VILLAGE OF GERMANTOWN
N112 W17001 MEQUON ROAD
GERMANTOWN, WI 53022

MEETING:	PLAN COMMISSION
DATE AND TIME:	MONDAY, AUGUST 28, 2017 6:30 p.m.
LOCATION:	Germantown Village Hall Board Room

SITE PLAN REVIEW

Plunkett Raysich Architects, agent for the Germantown School District, property owner, has submitted revised landscaping plans for the three (3) school sites for which site development and building plans were conditionally approved in May 2017, including: Germantown High School, Kennedy Middle School and County Line Elementary School.

WRENWOOD
CONCEPT PLAN

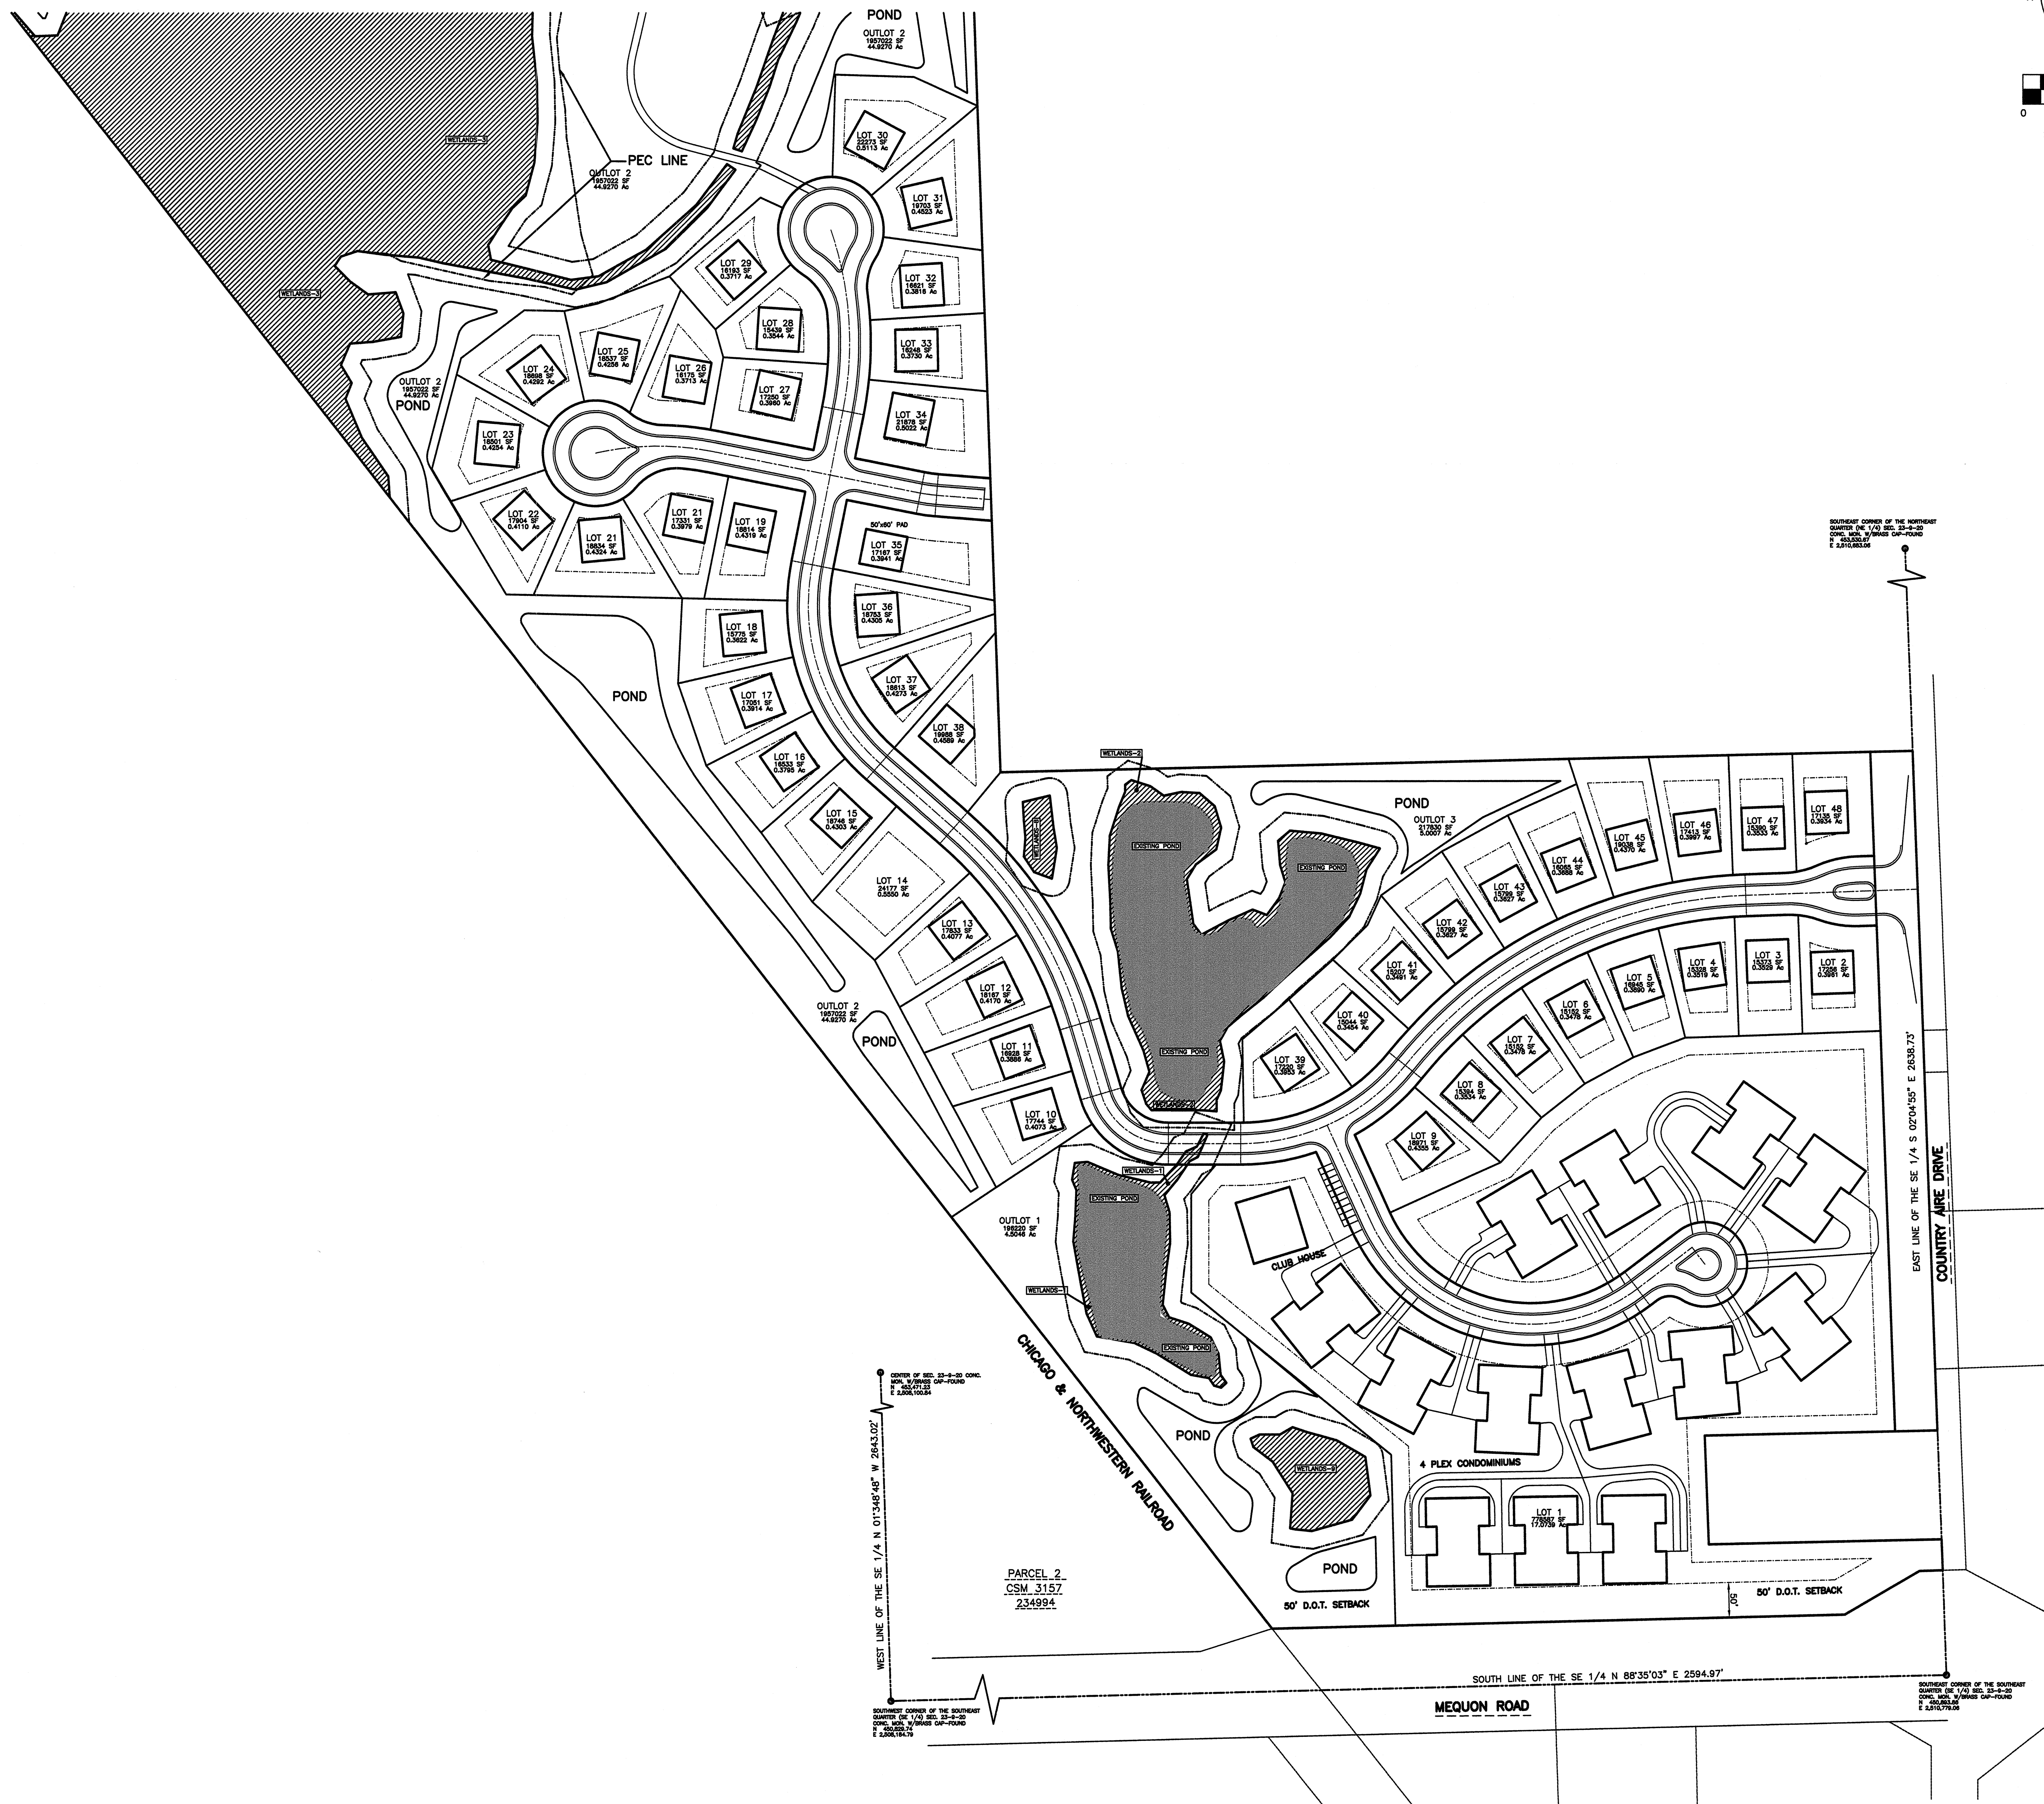
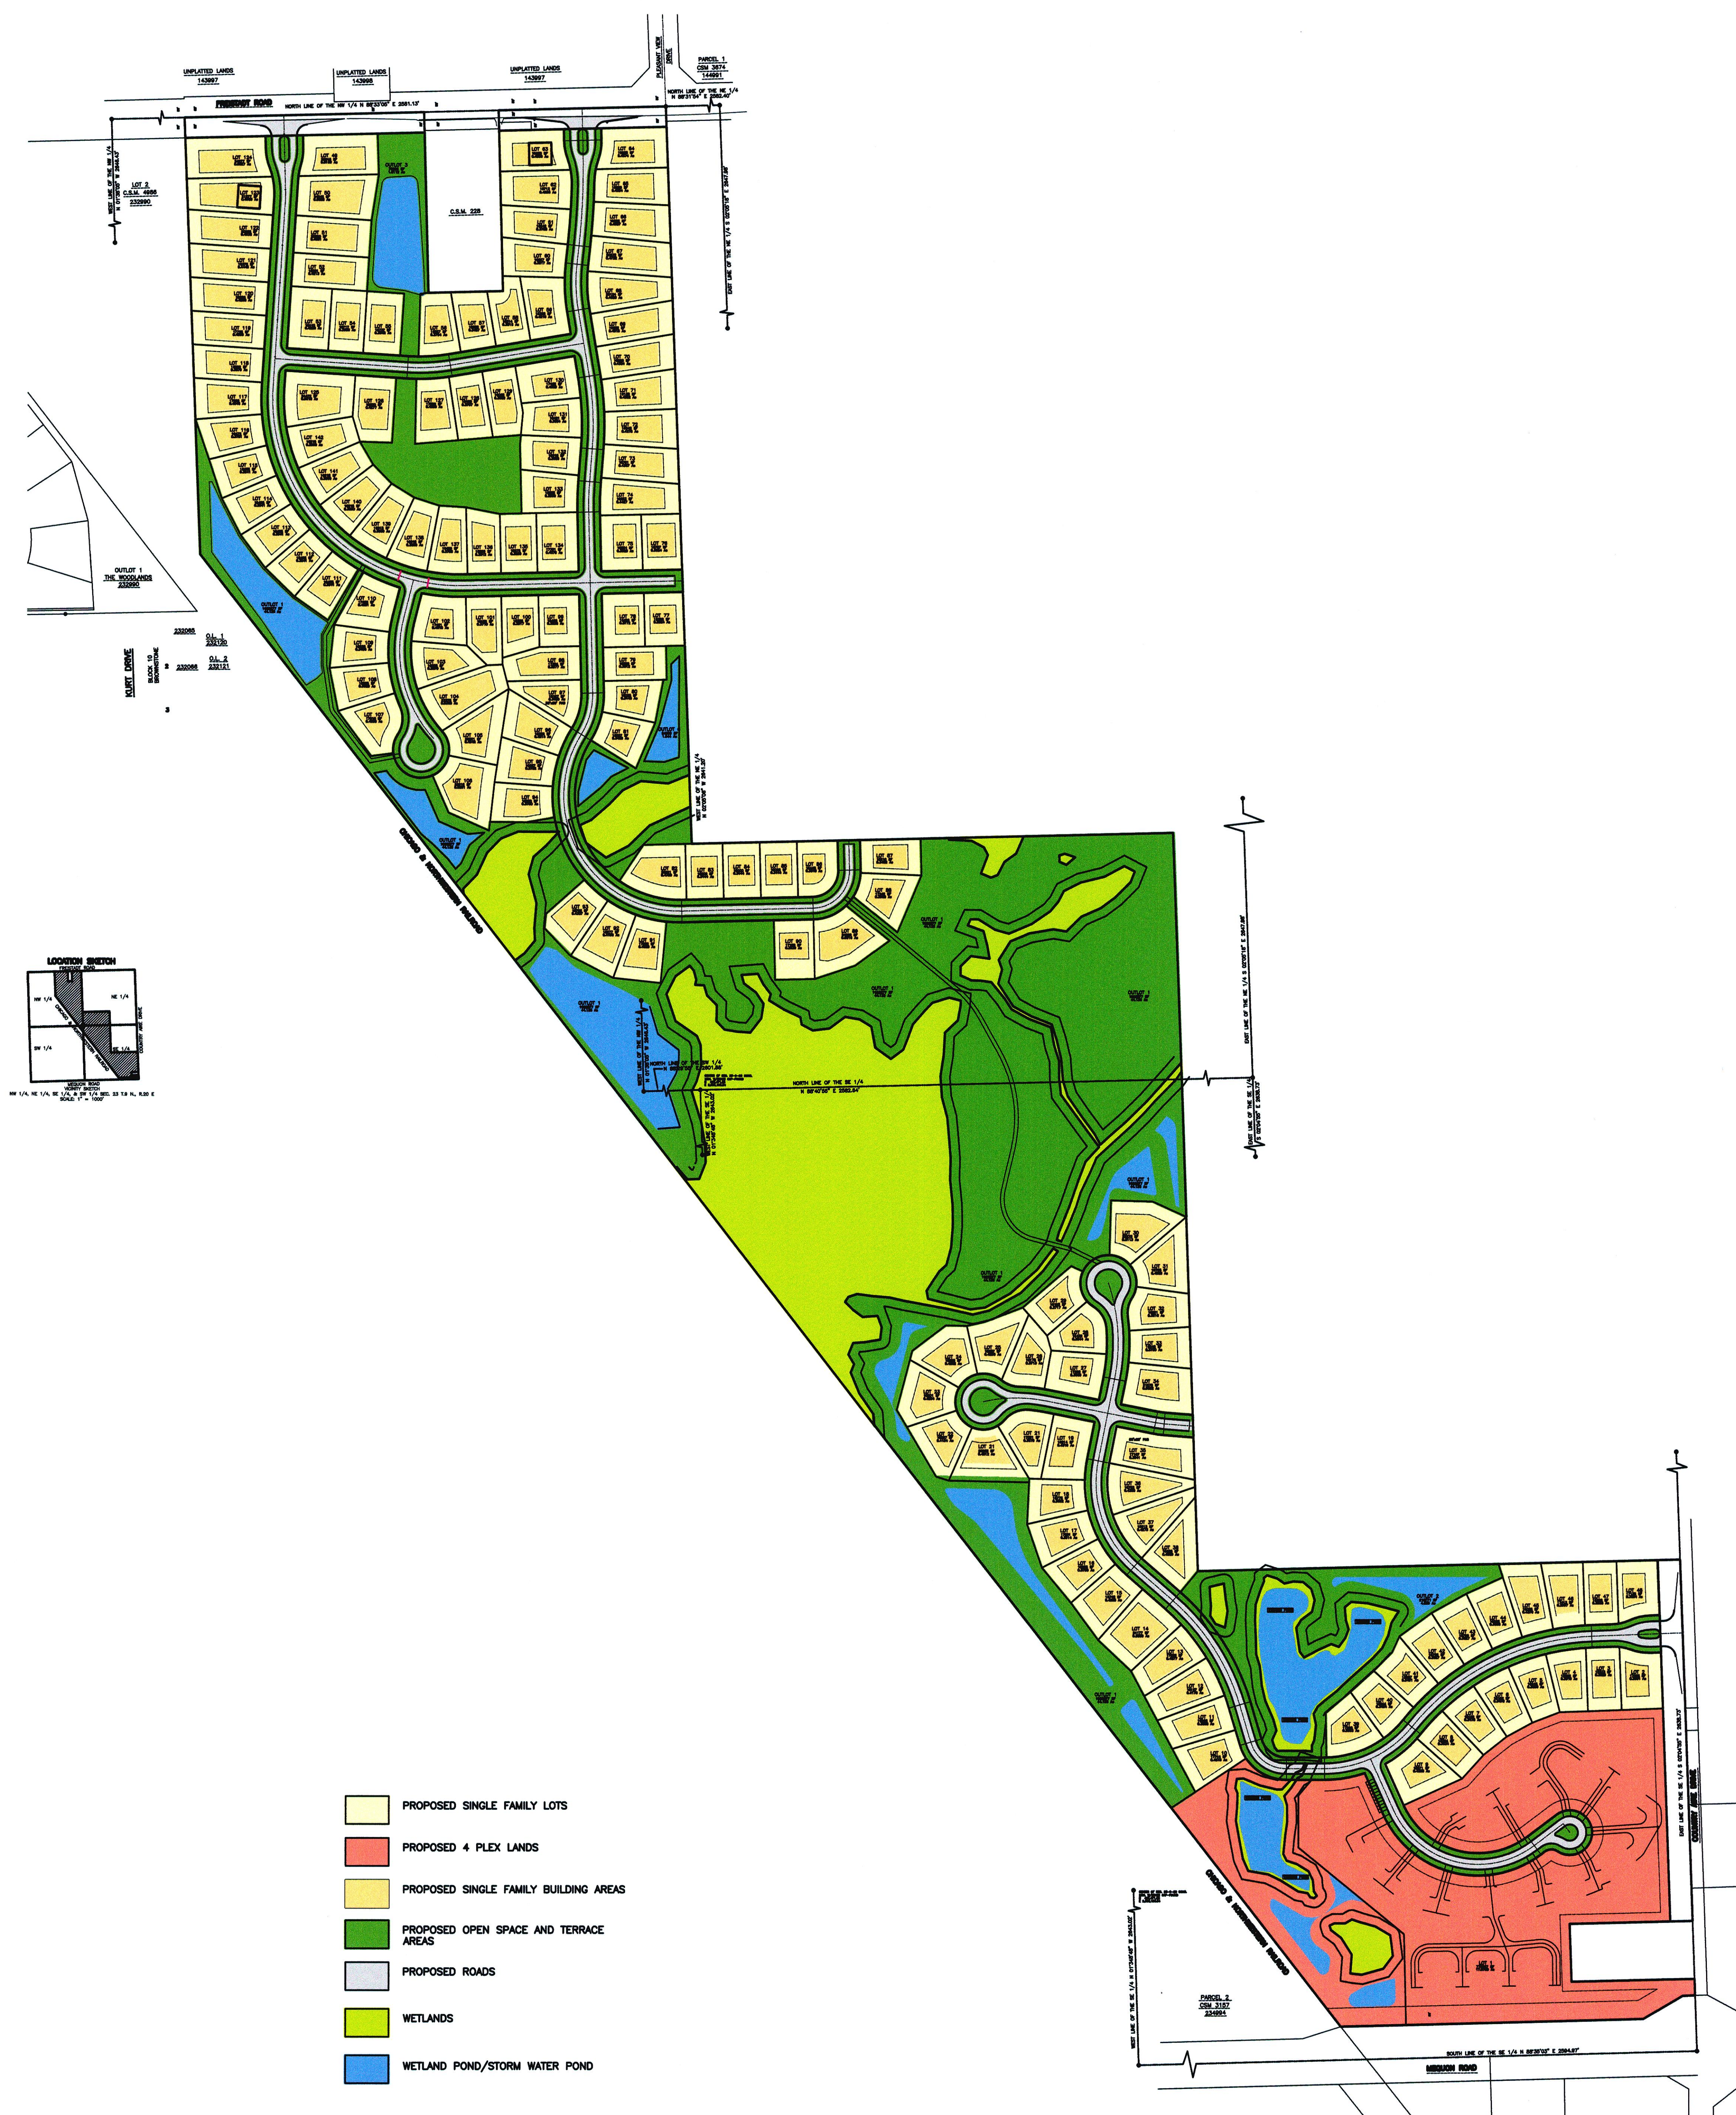
The proposed Wrenwood development is nearly identical to the original proposal in terms of road and lot layout that was reviewed by the Plan Commission and Village Board. A 15% increase in residential units (169 to 193) appears to be a reasonable trade-off for the elimination of 3.5 acres of potential commercial development along Mequon Road (that would have limited access to Country Aire Drive given WisDOT concerns with the limited amount of road frontage between Country Aire and the railroad tracks).

With that understanding, staff and the Applicant is requesting feedback on the new Wrenwood development concept plan that can be addressed before the LUP map amendment and rezoning applications are submitted for Village approval.
